Access Compliance Report
Public Rights-of-Way
(Curb Ramps)

Intersection ID: 10039270	**Main Street:** SUNSET_RD	**Cross Street:** N/A	**Location:**	**NW**
ADA ID: 3F10C76EBE6D	**Ramp Type:** Perp	**Initial Pass/Fail:** Pass	**Overall Compliance:** No	**Severity Score:** 0.25

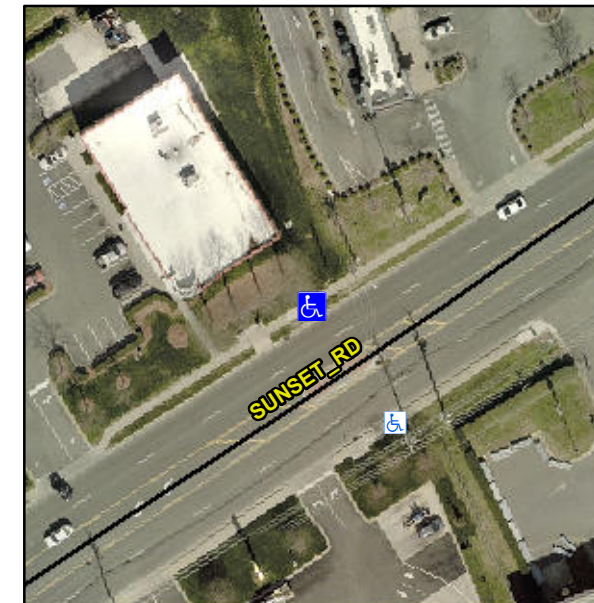
Not Found, R304.5.3

Compliance	Description	Data	Compliance	Description	Data
N/A	Ramp Length (in)	55.0	Yes	Ramp Slope (%)	5.3
Yes	Ramp Width (in)	58.0	No	Ramp XSlope (%)	2.2
Yes	Flare Type LT	Curbed_NoWalkSurface	Yes	Flare Type RT	N/A
Yes	Flare Slope LT (%)	N/A	N/A	Flare Slope RT (%)	N/A
N/A	Flare Traversable LT?	No	N/A	Flare Traversable RT?	No
Yes	Landing Length (in)	60.0	Yes	DWS Provided?	Yes
Yes	Landing Width (in)	58.0	Yes	DWS Contrast?	Yes
Yes	Landing Slope (%)	1.8	Yes	DWS Length (in)	24.0
Yes	Landing X Slope (%)	0.3	Yes	DWS Full Width?	Yes
N/A	Landing Curb? (Y/N)	Yes	Yes	DWS Offset (in)	0.0
N/A	Shared Landing?	No			
Yes	Gutter Ponding?	No	Yes	Gutter Slope (%)	2.5
Yes	Gutter Lip Ht (in)	0.0	No	Gutter X Slope (%)	2.6
N/A	Painted X Walk1?	No	N/A	Painted X Walk2?	N/A
	X Walk 1 Direction	To SE		X Walk 2 Direction	N/A
N/A	X Walk 1 Width (in)	N/A	N/A	X Walk 2 Width (in)	N/A
	X Walk 1 Slope (%)	0.6		X Walk 2 Slope (%)	N/A
	X Walk 1 X Slope (%)	1.6		X Walk 2 X Slope (%)	N/A

Remove & Replace Entire Ramp.
Remove & Replace Gutter.
